# **Comment Agenda**

## **162 cable assembly**

### **162A-D Annexes**

**Chris DiMinico**  
**MC Communications/PHY-SI LLC/Panduit**  
[cdiminico@ieee.org](mailto:cdiminico@ieee.org)

# CA DC RL – 71\*, 181, 148, 74,

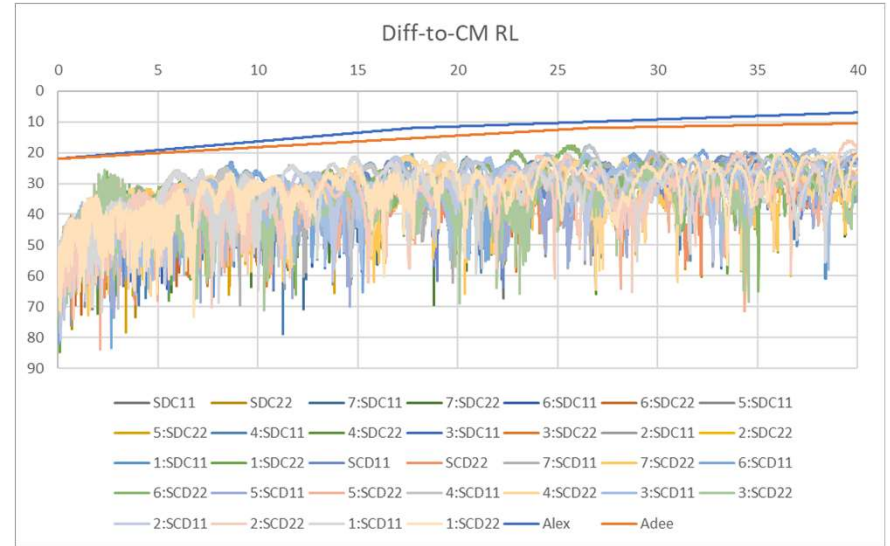
#71 haser\_3ck\_adhoc\_02\_061720.pdf

**802.3ck proposal:**

$$\left(22 - \frac{15}{26.56}f\right) \text{ dB} \quad 0.05 \text{ GHz} \leq f < 17.7 \text{ GHz}$$

$$\left(16 - \frac{6}{26.56}f\right) \text{ dB} \quad 17.7 \text{ GHz} \leq f \leq 40 \text{ GHz}$$

## common to differential mode RL proposals

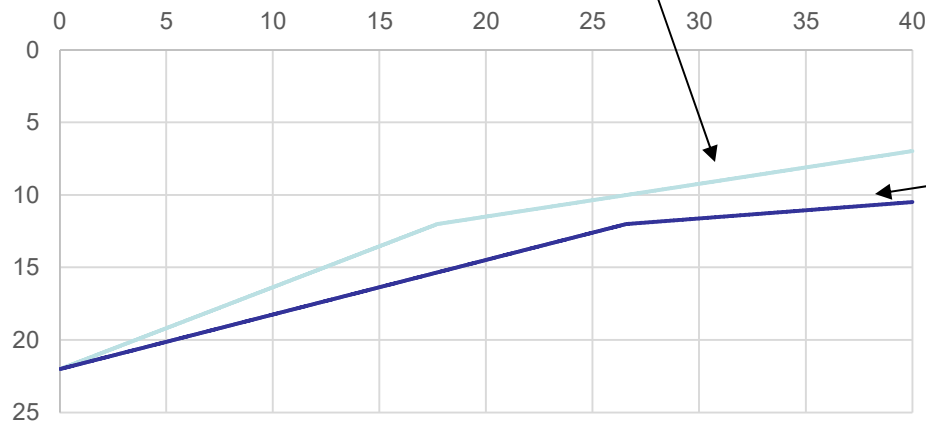
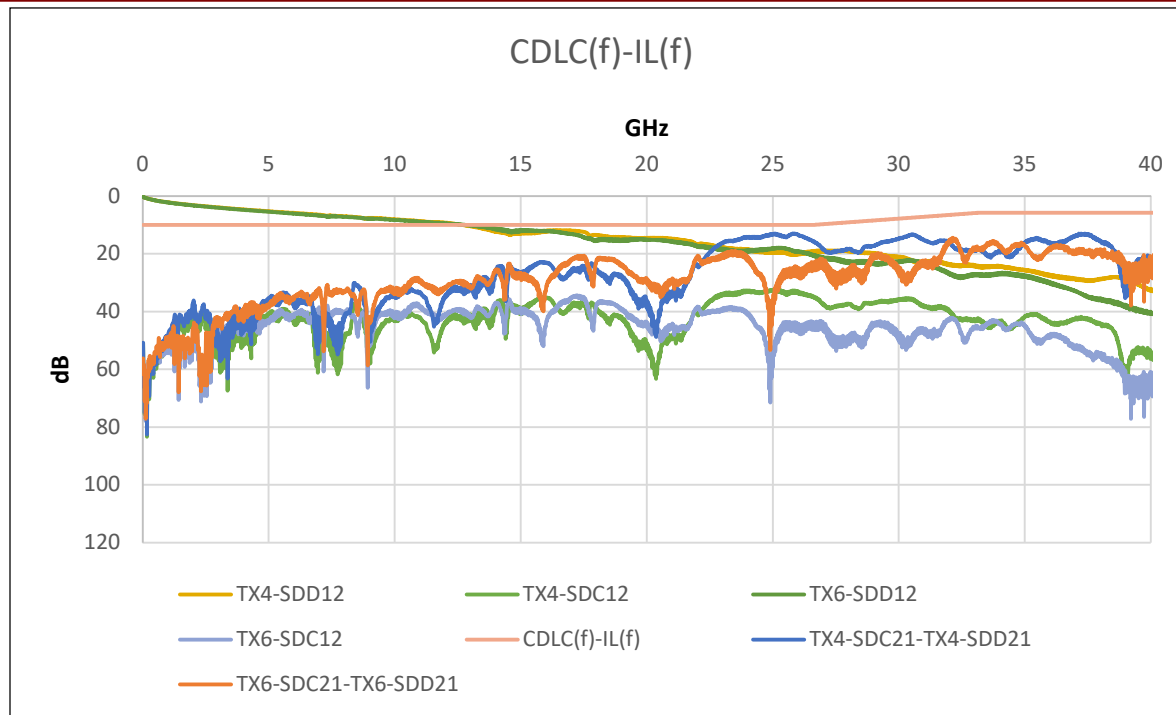
Alex # 71    Adee - #147

#147 ---CDRL(f) ≥  
 $22 - 10 * f / f_N, 0.01 \leq f \leq f_N$   
 $15 - 3 * f / f_N, f_N < f < 40$   
 Where  
 $f_N = 26.5625$  is the Nyquist frequency in GHz  
 f is the frequency in GHz

# CA CC RL – 73\*,181,76

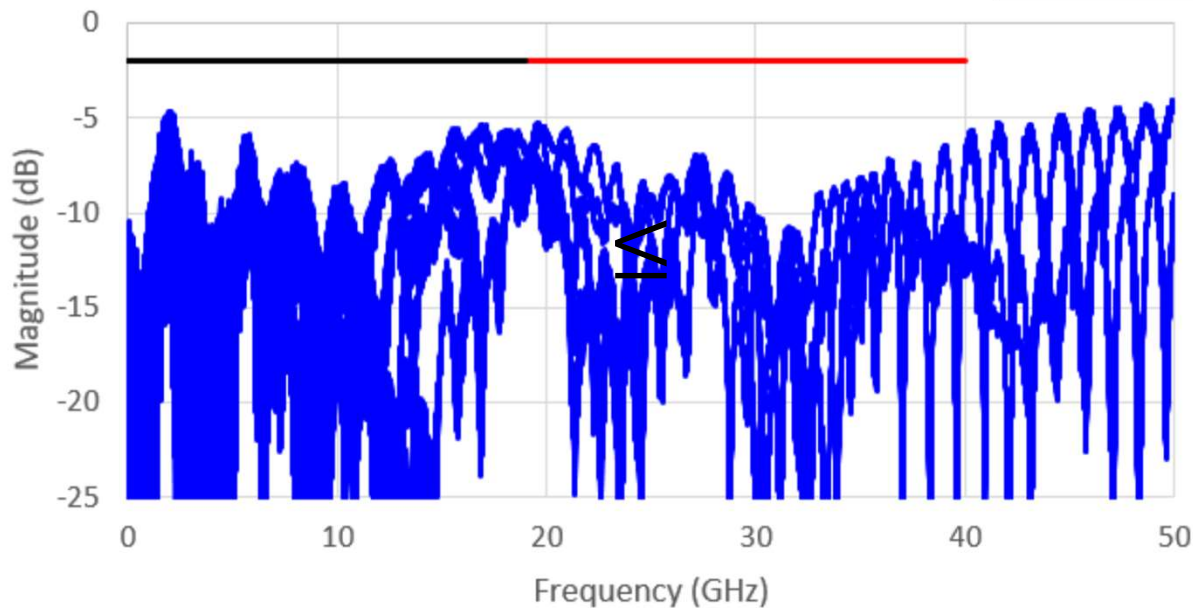
**802.3ck proposal:** 2 dB  $0.05 \text{ GHz} \leq f < 40 \text{ GHz}$

Figure 92A-1—Insertion Loss Tx or Rx PCB max and min

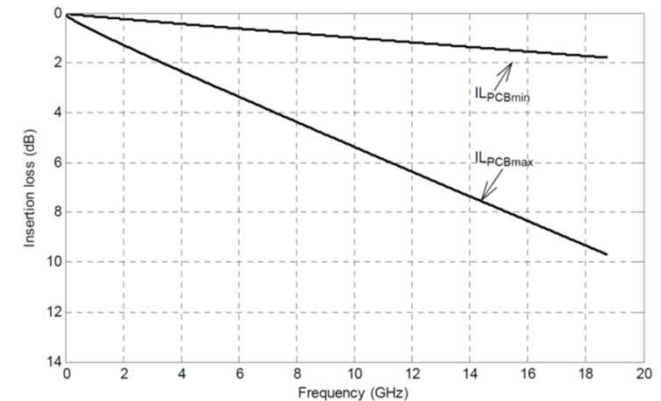
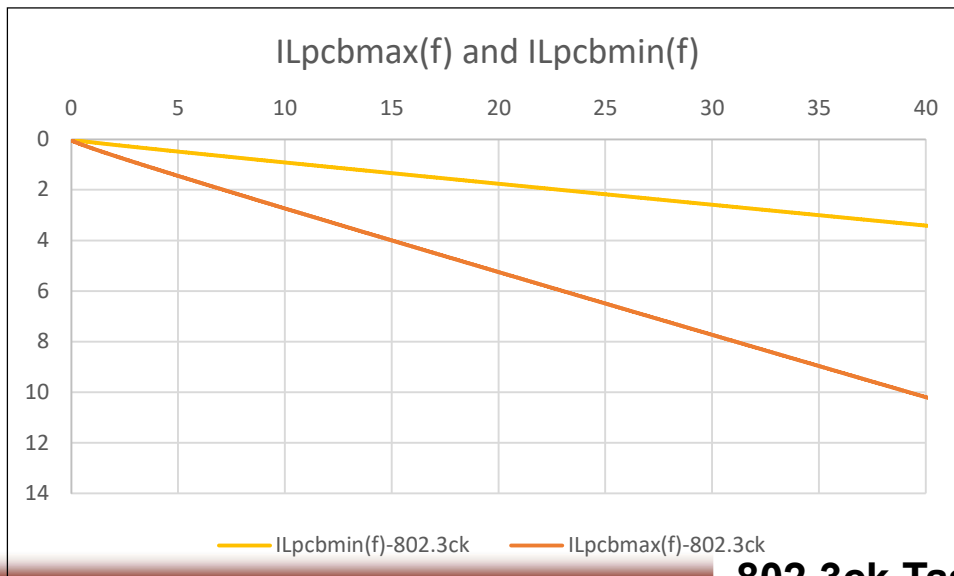
Note that the recommended maximum insertion loss allocation for the transmitter or receiver differential controlled impedance printed circuit boards with allowances for ball grid array (BGA) footprint and host connector footprints is 6.875 dB at 26.56 GHz and the recommended minimum insertion loss allocation for the transmitter or receiver differential controlled impedance printed circuit boards is 2.3 dB at 26.56 GHz. The recommended maximum insertion loss allocation for the transmitter or receiver differential controlled impedance printed circuit boards is consistent with the insertion loss from TP0 to TP2 or TP3 to TP5 given in **TBD** and an assumed mated connector loss of 1.6 dB.

$$IL_{pcbmax}(f_{ghz}) = 0.0176 + 0.1082 * \text{SQRT}(f_{ghz}) + 0.2372 * f_{ghz}$$

$$IL_{pcbmax}(26.56) = 6.875 = 0.0176 + 0.1082 * \text{SQRT}(26.56) + 0.2372 * 26.56$$

$$IL_{pcbmin}(f) = 0.0059 + 0.0361 * \text{SQRT}(f_{ghz}) + 0.0794 * f_{ghz}$$

$$IL_{pcbmin}(26.56) = 2.30 = 0.0059 + 0.0361 * \text{SQRT}(26.56) + 0.0794 * 26.56$$

Editorial license update Annex reference to 162.11.2 ILCamin

# #86,87 - MTF Differential Return Loss

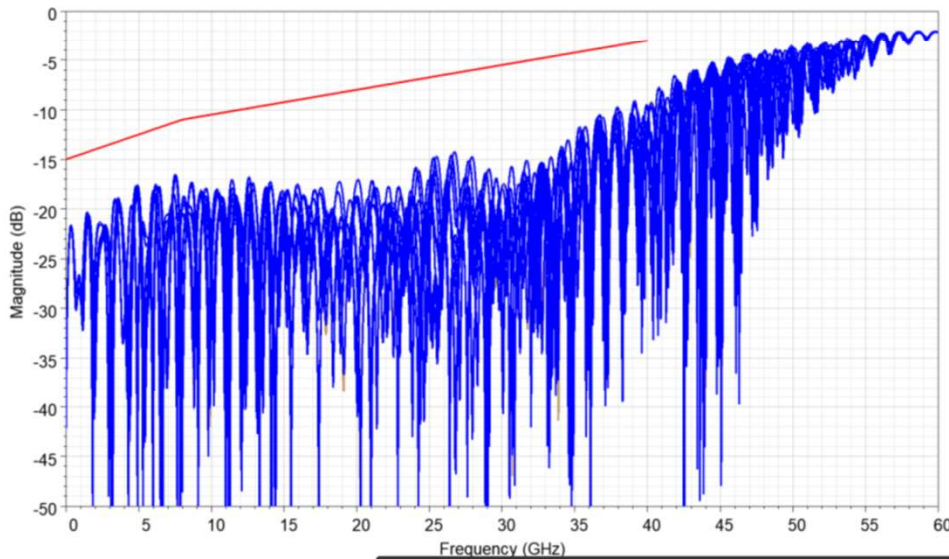
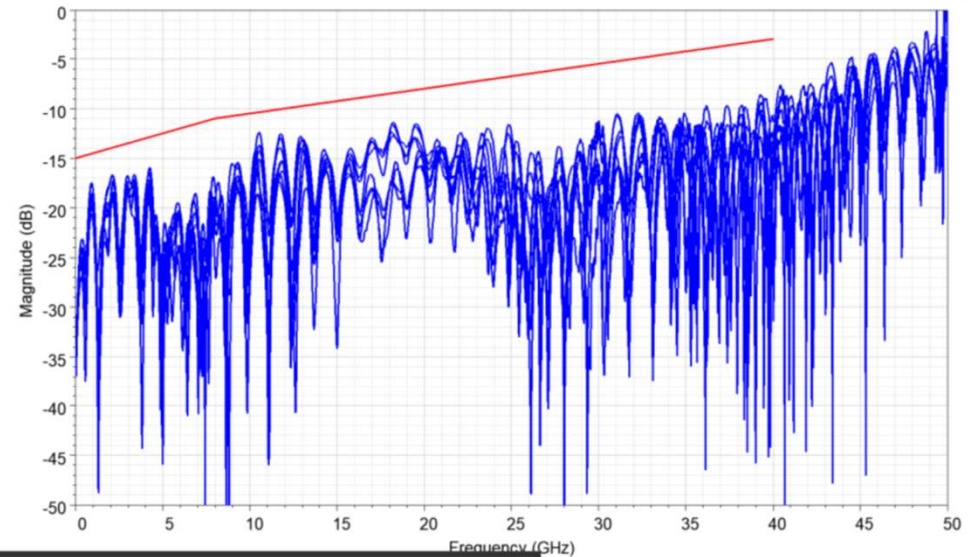
#86,#87 - 162B.1.3.2 Mated test fixtures - **RL (TBD)** - Change from 0.01 GHz  $\leq f_{\text{GHz}} \leq 50$  GHz to **0.05 GHz  $\leq f_{\text{GHz}} \leq 40$  GHz** and update figure.

Proposal:  $15 - 0.5f$   $f < 8 \text{ GHz}$   
 $13 - 0.25f$   $8 \text{ GHz} \leq f \leq 40 \text{ GHz}$

# #88,#89 -162B.1.3.4 Mated test fixtures - CMCIL

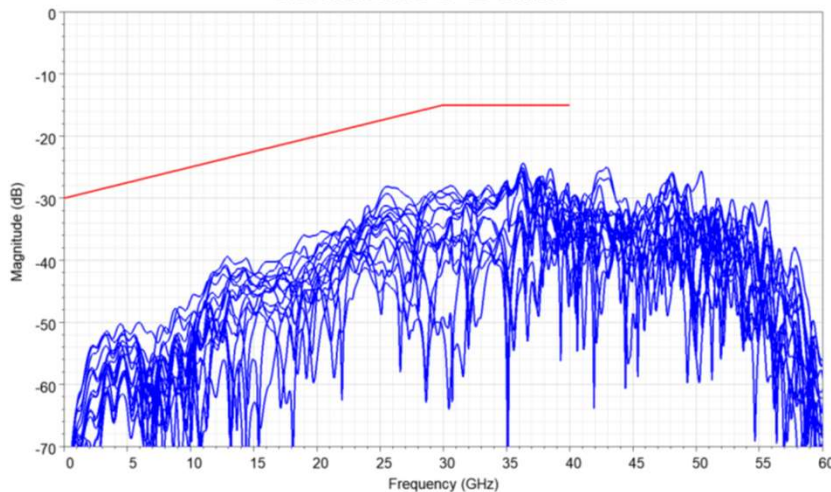
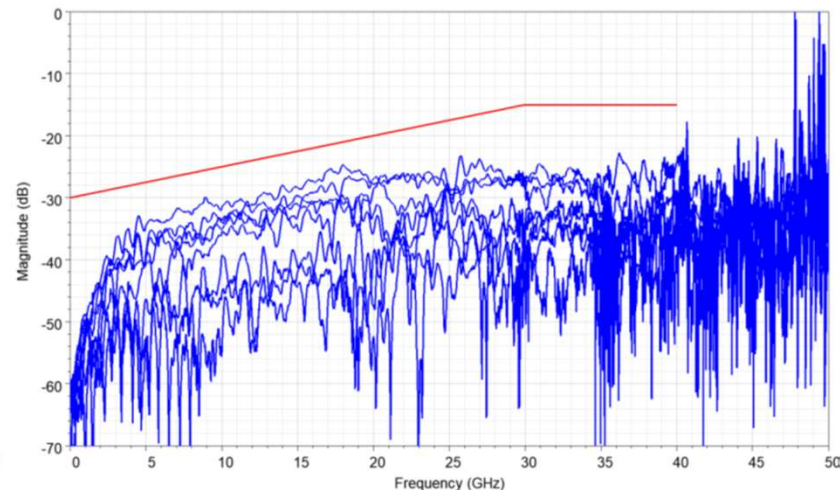
#88,#89 - 162B.1.3.4 Mated test fixtures - **CMCIL (TBD)** - Change from  $0.01 \text{ GHz} \leq f_{\text{GHz}} \leq 50 \text{ GHz}$  to  $0.05 \text{ GHz} \leq f_{\text{GHz}} \leq 40 \text{ GHz}$  and update figure.

Proposal:	$30 - 0.5f$	$f < 30 \text{ GHz}$
	15	$30 \text{ GHz} \leq f \leq 40 \text{ GHz}$

# IL Frequency range Max – 79, 80, 81,82

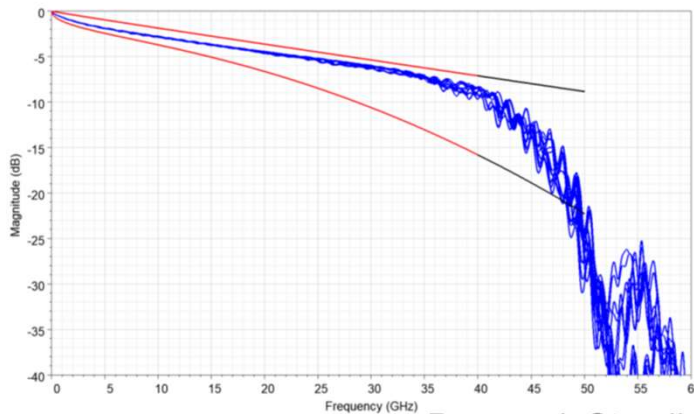
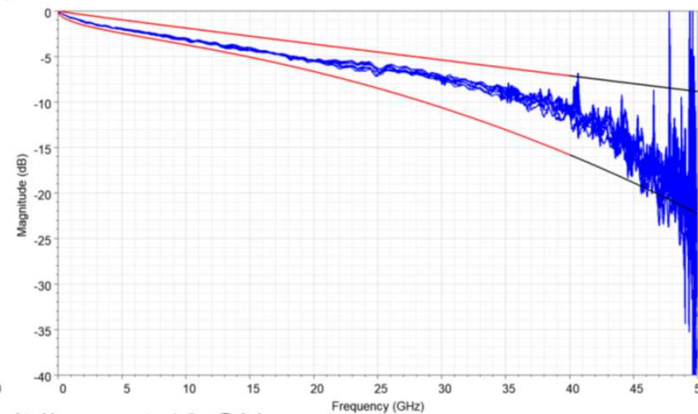
#79- 162B.1.1.1 Reference IL - Change from  $0.01 \text{ GHz} \leq f_{\text{GHz}} \leq 50 \text{ GHz}$  to  $0.05 \text{ GHz} \leq f_{\text{GHz}} \leq 40 \text{ GHz}$  and update figure.

#80- 162B.1.2.1 Cable assembly test fixture reference IL - Change from  $0.01 \text{ GHz} \leq f_{\text{GHz}} \leq 50 \text{ GHz}$  to  $0.05 \text{ GHz} \leq f_{\text{GHz}} \leq 40 \text{ GHz}$  and update figure.

#81,#82- 162B.1.3.1 Mated test fixtures max and min IL - Change from  $0.01 \text{ GHz} \leq f_{\text{GHz}} \leq 50 \text{ GHz}$  to  $0.05 \text{ GHz} \leq f_{\text{GHz}} \leq 40 \text{ GHz}$  and update figure.

Proposal: Stop limit lines at 40 GHz

# In support of IL Frequency range Max – 79, 80, 81,82

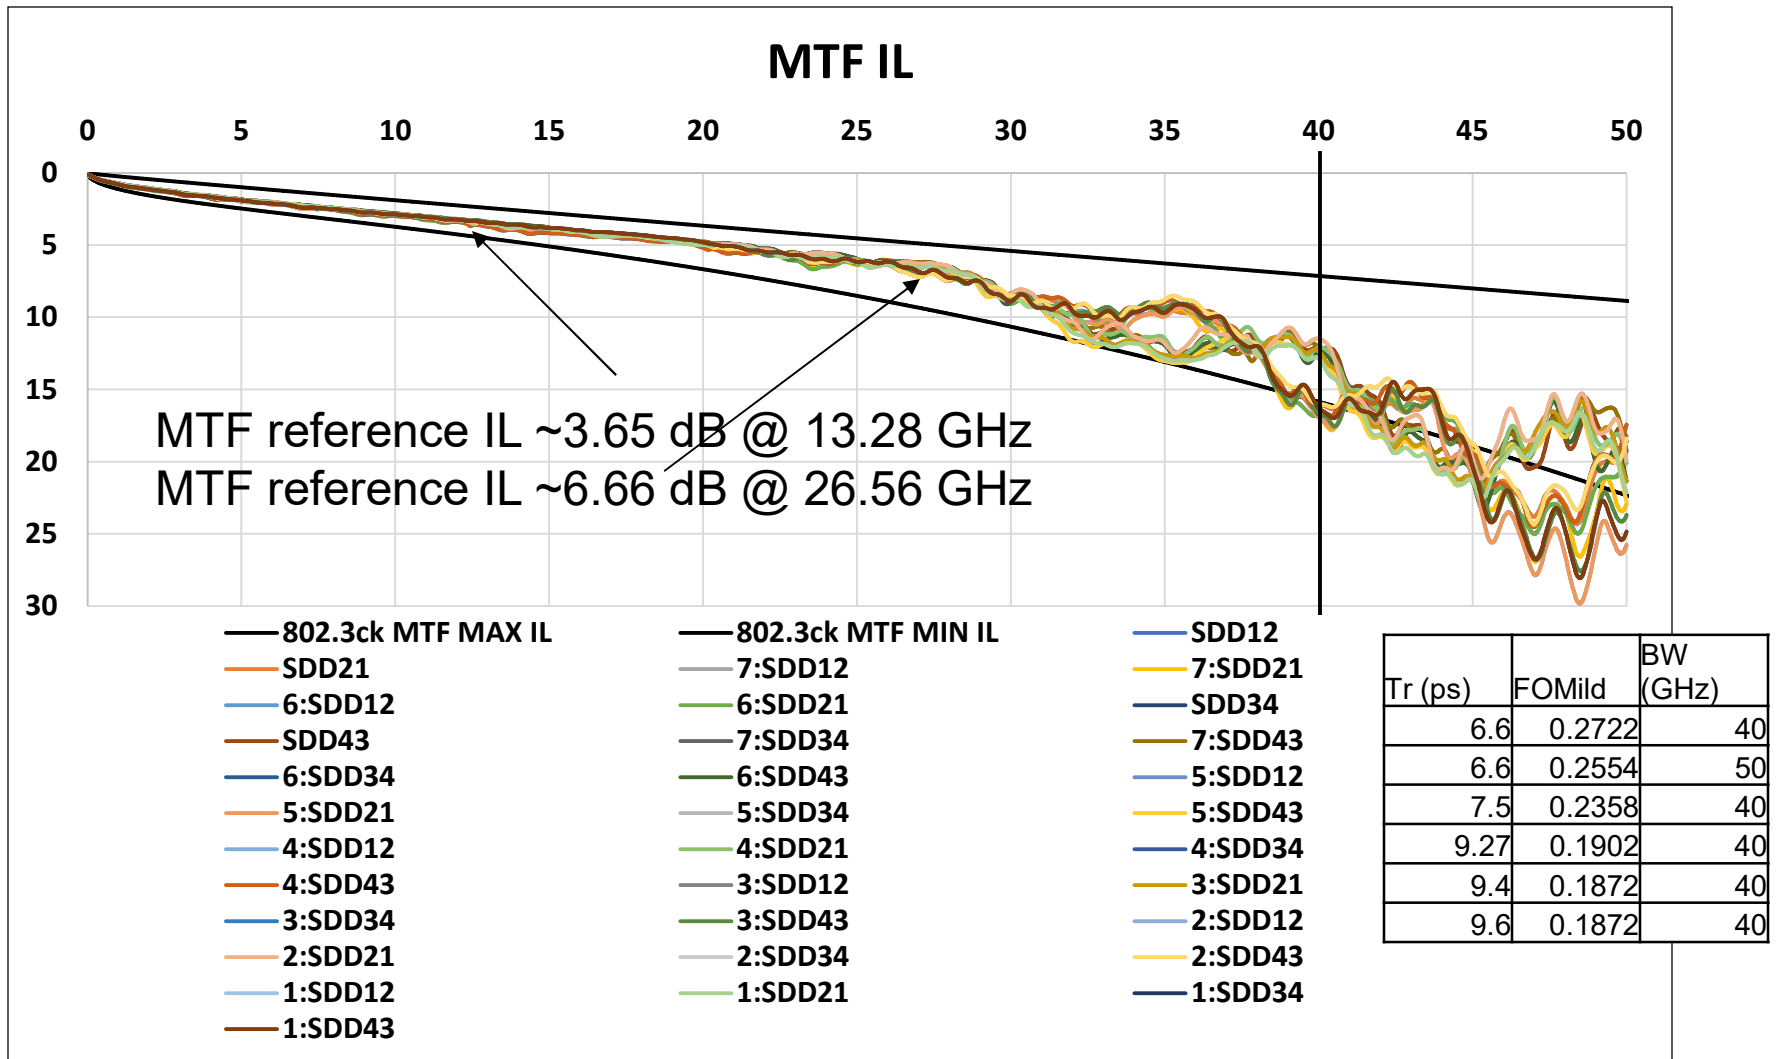
- Measurements with compliant PCB IL - HCB and MCB
